PLANT NAME: Oconee 1-3

AMDT to OL/Change to Tech Specs: Consisting of revisions with regard to miscellaneous topics with the intent to update & improve existing tech specs.....

Re: Oconee Nuclear Station
Docket Nos. 50-269, -270, -287

Pursuant to 10CFR50, §50.90, an amendment to the Oconee Nuclear Station Technical Specifications, Appendix A to Facility Operating Licenses DPR-38, -27, and -55 is requested. These proposed changes concern several miscellaneous topics and are intended to update and improve the Oconee Technical Specifications. Replacement pages for these proposed changes are attached.

OCONEE NUCLEAR STATION
STATION ORGANIZATION CHART
FIGURE 6.1-1

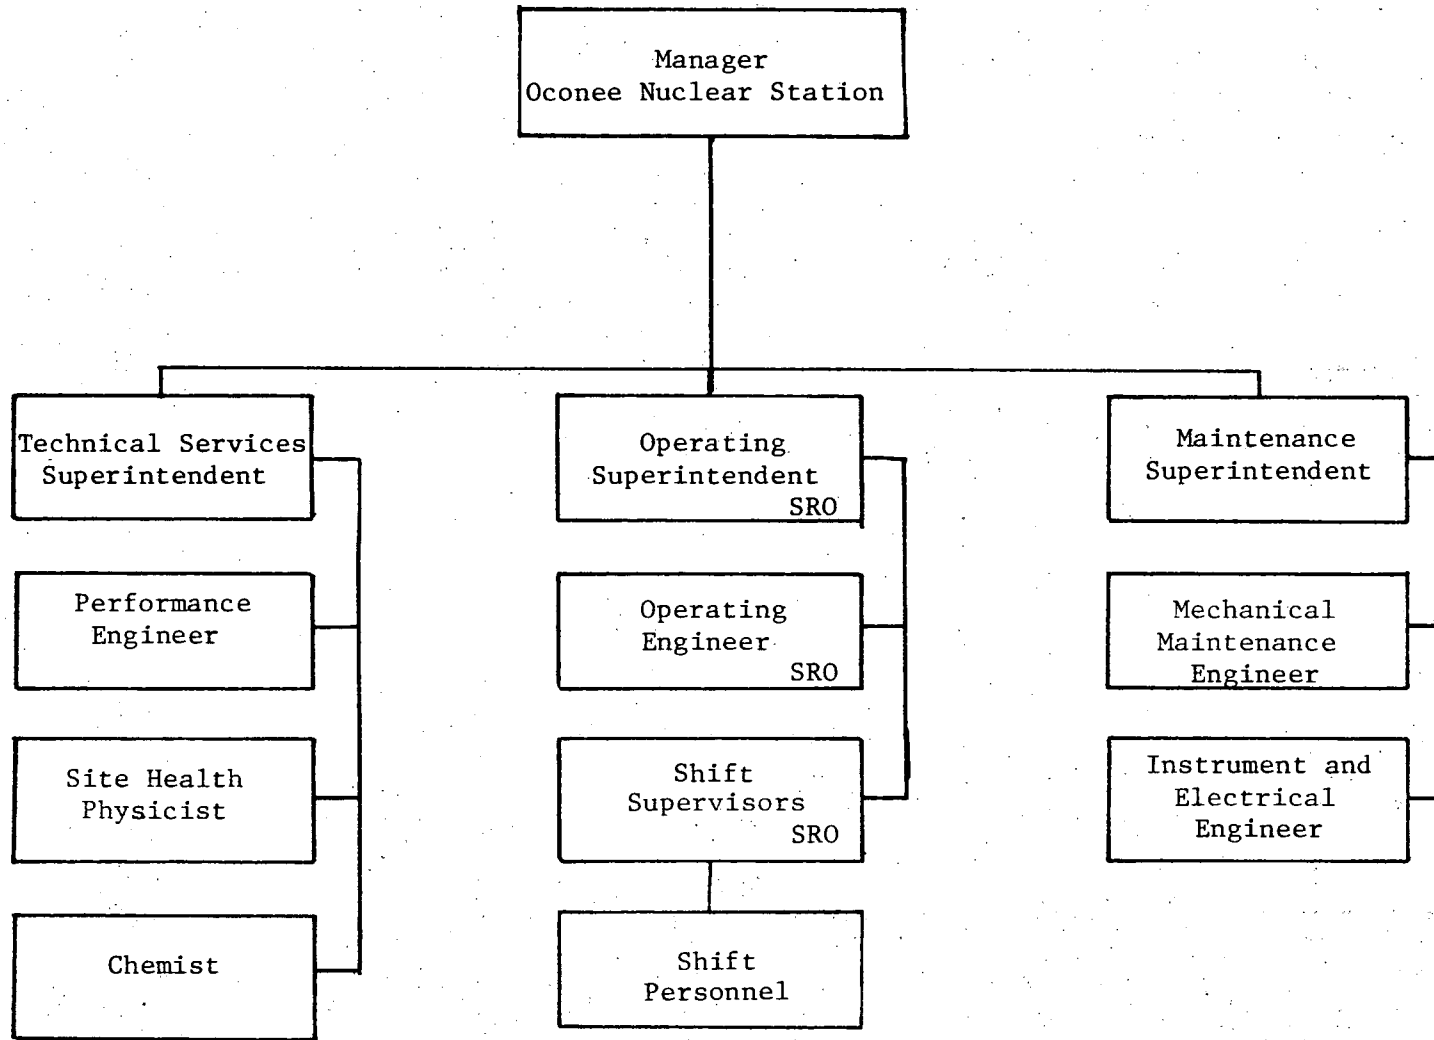
6. Technical Specifications 3.5.2.7, Table 4.11-1, 6.4.1, 6.5.2 and Figure 6.1-1 have been revised as indicated to reflect recent administrative changes and are self explanatory.
